Subject: Response to Request for Additional Information – WCAP-15872-NP, Rev. 0, “Use of Alternate Decay Heat Removal in Mode 6 Refueling.”

**WCAP-15872, "Use of Alternate Decay Heat  
Removal in Mode 6 Refueling"**

**WCAP-15872-NP, R00**  
**"Use of Alternate Decay Heat Removal in Mode 6 Refueling"**  
**Request for Additional Information**  
**dated October 2, 2003**

Figure A-3  
Sample Cases: Average Refueling Pool Temperature

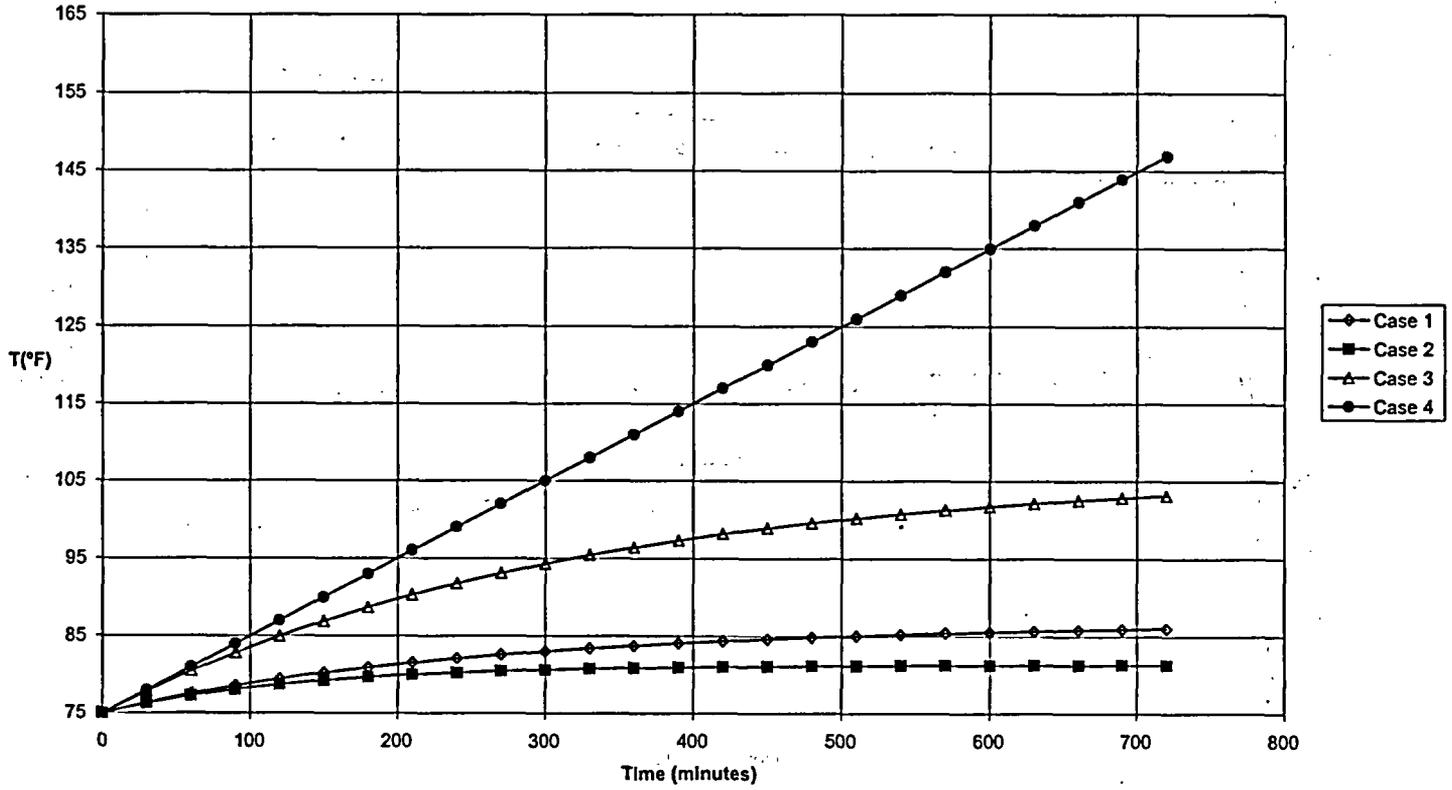
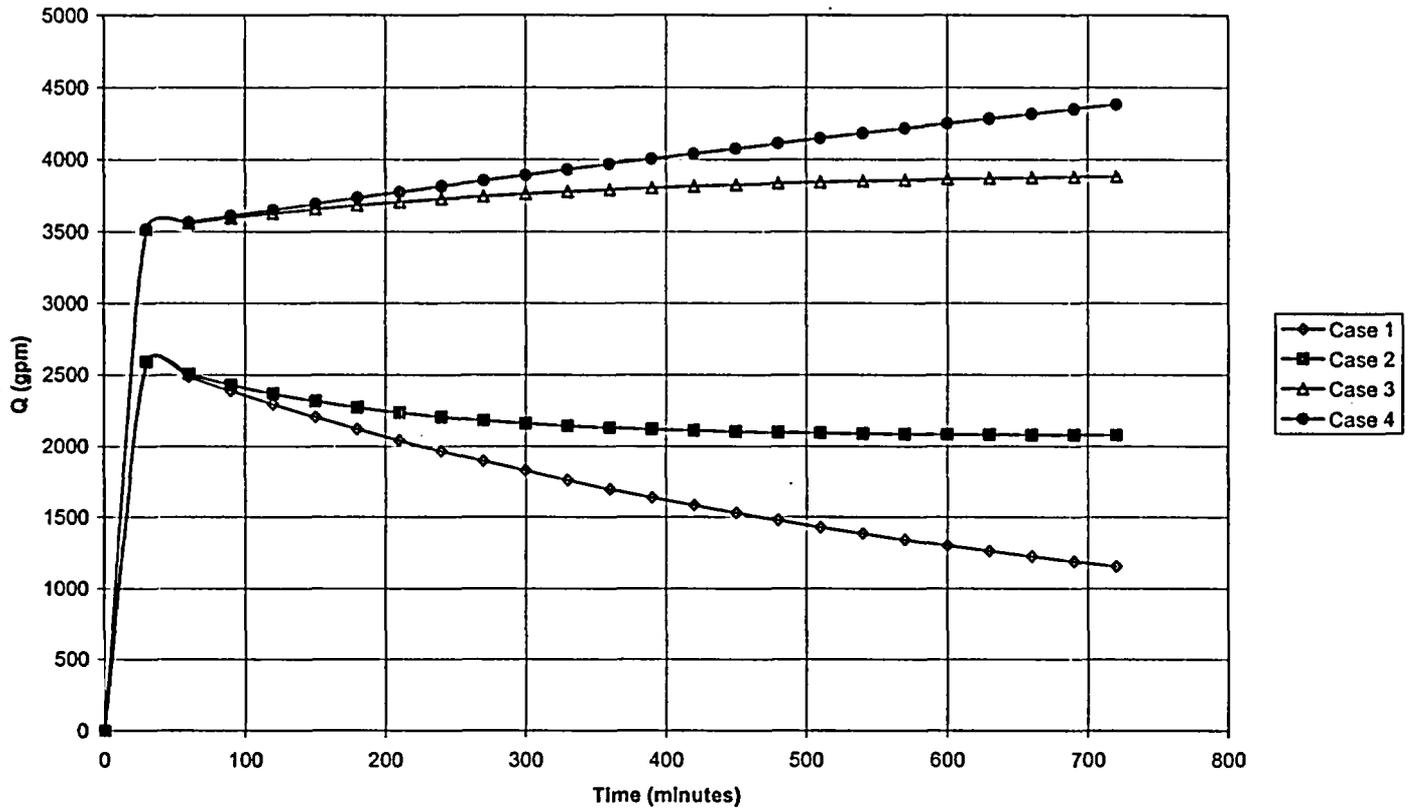
*RAI A7. Please show the derivation of the values of  $\epsilon_{mix}$  and  $\epsilon_{bypass}$  used in the results shown in Figs. A-3 and A-4 for Case 2 and Case 3.*

The mixing and bypass coefficients are defined in Appendix A and derived as shown in Appendix D. However, for the results shown in Figure A-3 and Figure A-4, these coefficients were assumed well mixed, i.e.,  $\epsilon_{mix} = 1.0$  and all alternate heat removal flow fully mixed with the natural convection flow from the core,  $\epsilon_{bypass} = 0.0$ . In Appendix A, Case 2 represents full SDC flow plus alternate cooling flow; Case 3 represents only alternate cooling flow. (Note that sample Cases 1 – 4 in Appendix A are not the same as test Cases 1 – 4 listed in Appendices B, C and D.)

Figure B-4  
CCNPP Unit 2 Outage Tests: Spent Fuel Pool Flow Rate and Temperature versus Time

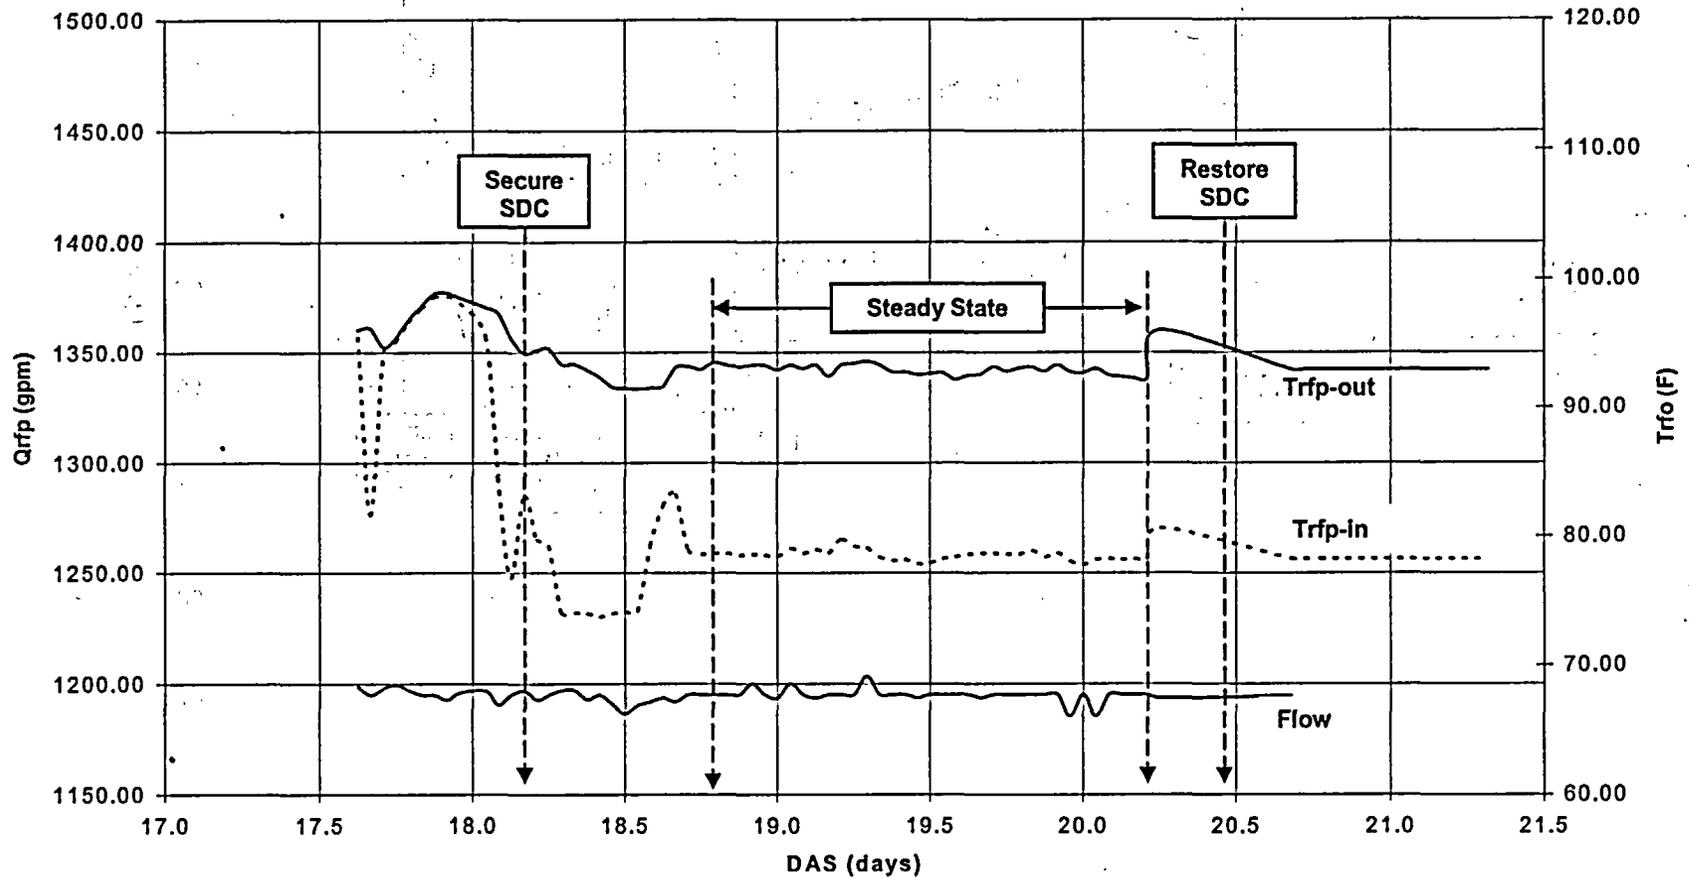
*RAI B4. Table B-2, B-3 and B-4 report time in days, hours and minutes respectively. Also, the figures use two different time scales. Please resubmit for review all tables and figures based on one time scale. (If there is a specific reason, such as clarifying a relationship, state so.)*

Time scales in Tables B-2, B-3 and B-4 are expressed in terms of clock time, total elapsed time and time in days after shutdown in order to expediently illustrate a particular result. For example, an event having a duration of minutes is not easily illustrated if expressed using a time-scale of days. Total elapsed time is used to compare measured and predicted values, while days after shutdown is the important parameter for tracking the point at which changes such as initiation and securing of shutdown cooling, head removal, initiation and securing of alternate cooling, and return to shutdown cooling occur.

**Figure D-2**  
**Flow Paths for Bypass Flow**

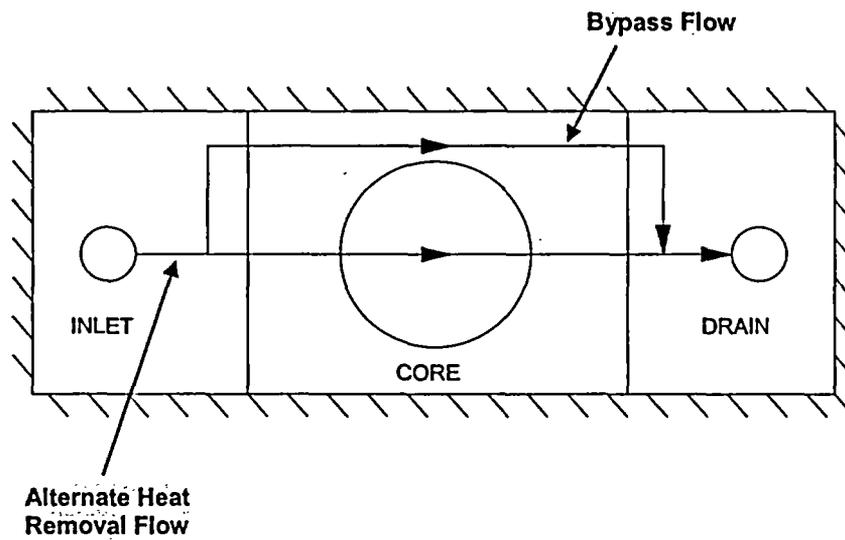
*RAI D1. Please describe the simplified one-dimensional computational model and its relation to the two-dimensional computational fluid dynamics model. How does it differ from the one-dimensional model discussed in Appendix A? When you say "computational fluid dynamics model" (without the adjective "one-dimensional") in D.3, what are you referring to - A 3D model? Figures D-3 through D-6 give 2D results. So, how are you treating the situation in Figure D-2?*

The mixing and bypass coefficients reflect three-dimensional effects into the one-dimensional analysis, shown in Appendix A, for natural circulation flow rates and refueling pool temperatures. The mixing coefficient is a measure of the uniformity of the refueling pool temperature, while the bypass coefficient, represented schematically in Figure D-2, is an indicator of the flow rate from the alternate cooling alignment that bypasses the natural circulation plume from the core.
